MEMORANDUM FOR: Themis P. Speis, Director, Division of Safety Technology
FROM: Roger J. Mattson, Director, Division of Systems Integration
SUBJECT: REQUEST FOR PRIORITIZATION OF GENERIC SAFETY ISSUE FOR
FAILURE OF HPCI STEAM LINE WITHOUT ISOLATION

SUBJECT: PRELIMINARY REVIEW OF SHOREHAM PRA STUDY

SUBJECT: INTERIM REPORT ON HPCI/RCIC/RWCU LINE BREAK IN SHOREHAM REACTOR BUILDING

REQUEST FOR INFORMATION

ATTACHMENT 1

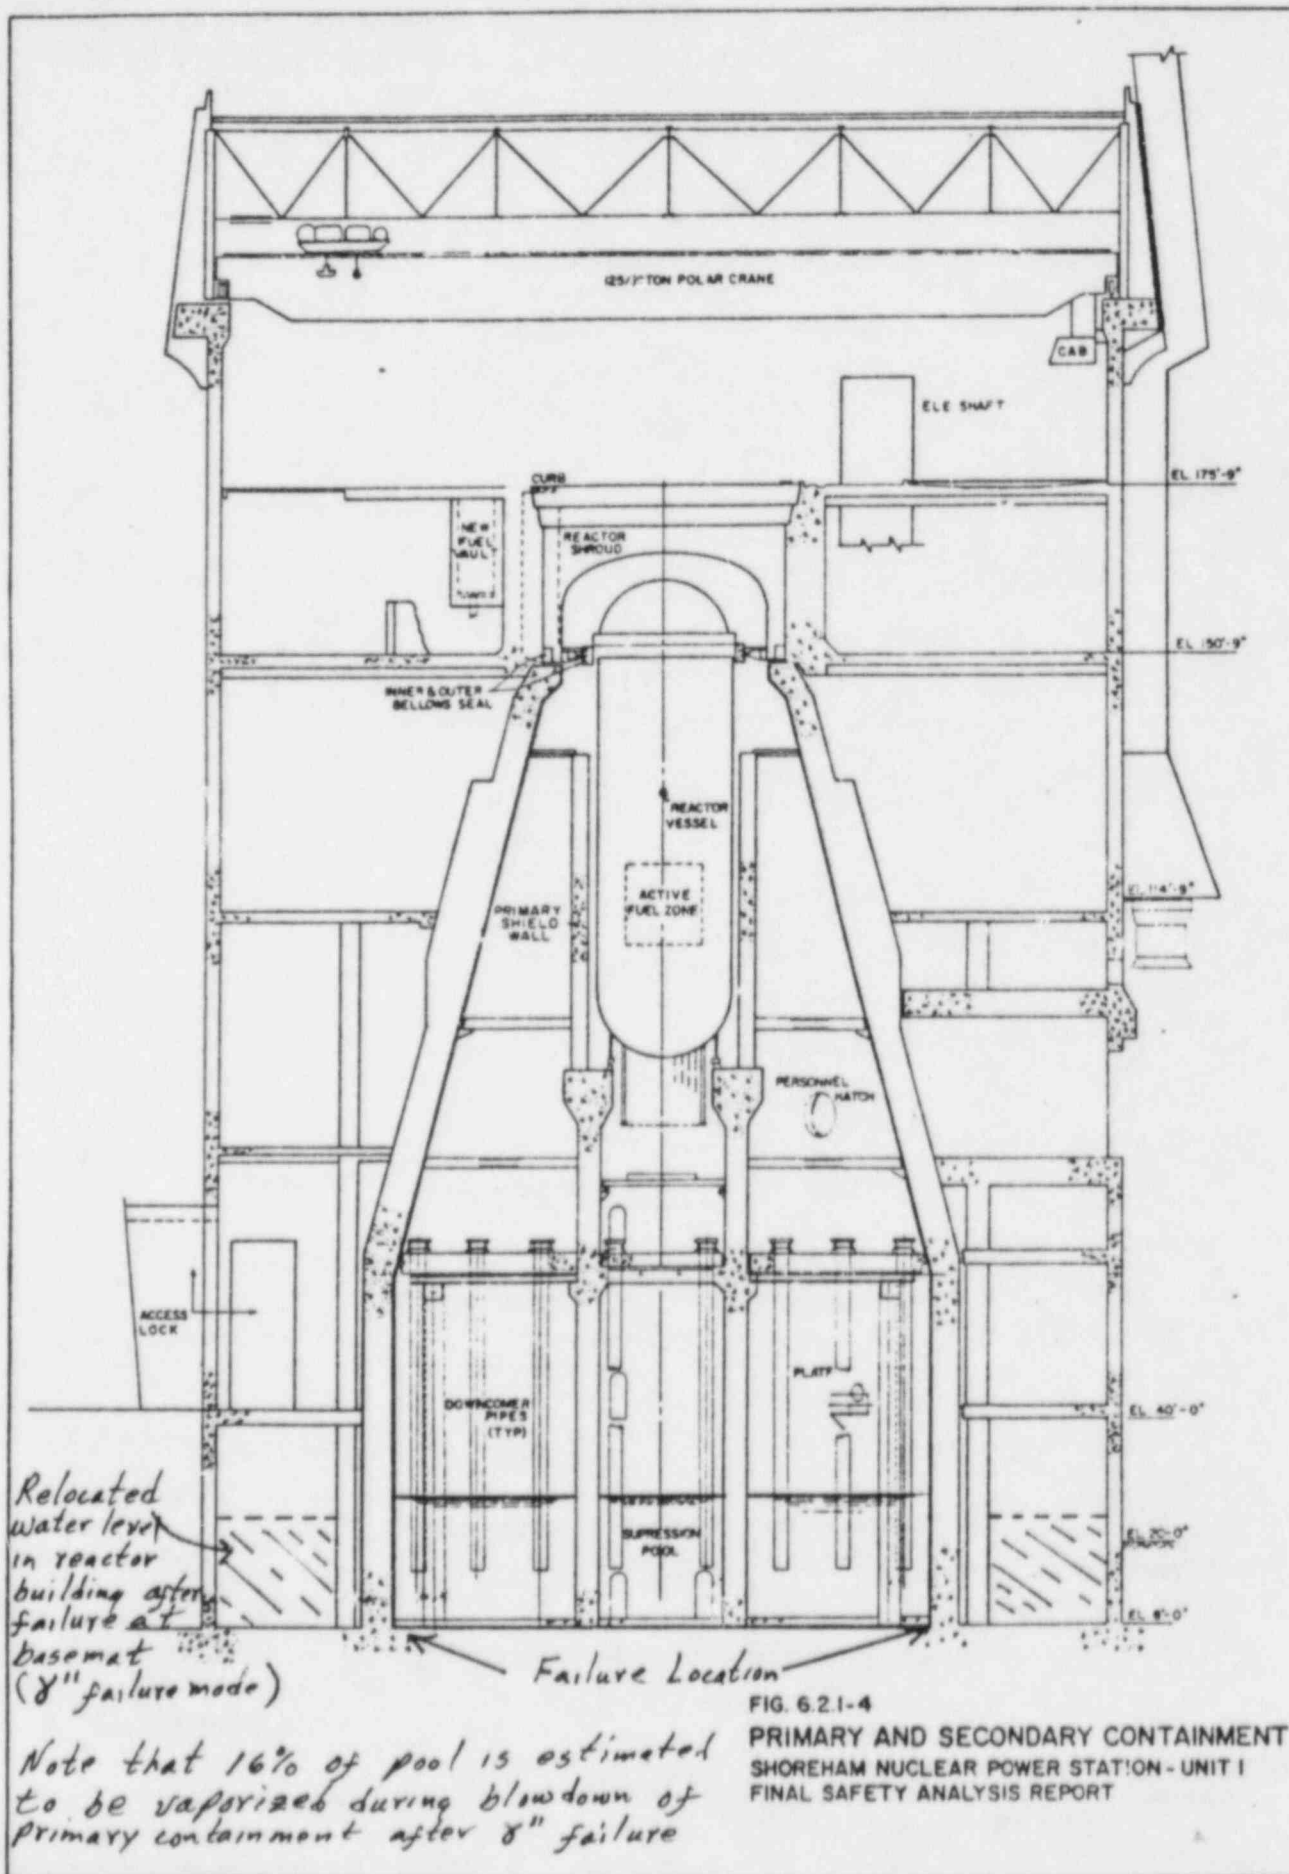
1. Table II of Appendix M gives different pressure limits for the longitudinal reinforcement bars at the base of the containment and in the wetwell region. However, the longitudinal bars appear to be continuous and should therefore have the same stress. Please explain the basis for the different results.

2. Table II of Appendix M indicates that the shear bars at the base and drywell head have the lowest pressure holding capability (121 psi and 120 psi, respectfully) but the discussion indicates that the additional reinforcement will preclude this failure mode. Since the containment failure mode is a key ingredient of the release estimates, please provide a quantitative estimate of the additional shear strength provided by the non-shear reinforcement bars.

3. If shear failure is precluded as discussed in Section 3.2 of Appendix M, "it appears that the ultimate capacity is controlled by the yield of the longitudinal and the hoop bars at about 123 psi." These two failure modes appear to be very important to subsequent fission product release (particularly for Class IV ATWS) since they will both occur in the wetwell region. Please provide an estimate of the size, location and direction (vertical or horizontal) containment failures for each of the three possible failure modes.

4. Section 3.6 of the PRA takes credit for containment leakage which will prevent gross containment failure for all pressurization rates except the very rapid pressurization associated with large breaks. However, the structural analysis by Stone and Webster (Appendix M) did not identify any significant source of leakage. The basis for the expected leakage source and the leakage rate as a function of pressure should be provided.

5. The basis for the partitioning between release category 10 and 11 (no pool bypass vs. partial pool bypass) should be provided. The phenomenological basis for the estimate of only 10% bypass should be provided. Preliminary results from IDCOR indicate that for some BWR sequences the vessel will fail with only 20% of the core molten. Presumably 80% of the melt release would bypass the SRV's and be released into the drywell.

6. The basis for binning into release categories is poorly described and the transfer from Tables H.4-8 etc. into the 16 release categories is difficult to interpret. A table listing the specific sequences which are binned into each category should be provided.

7. The lack of R_5 sequences in the release categories makes it apparent that these releases have been binned "downward" into the lesser release category R_4 . The basis for this "downward" binning and any other sequences that are moved to less severe categories should be provided.

8. Table H.4-25 appears to be incomplete in that it does not include sequences D6 and D8. The completed table should be provided.
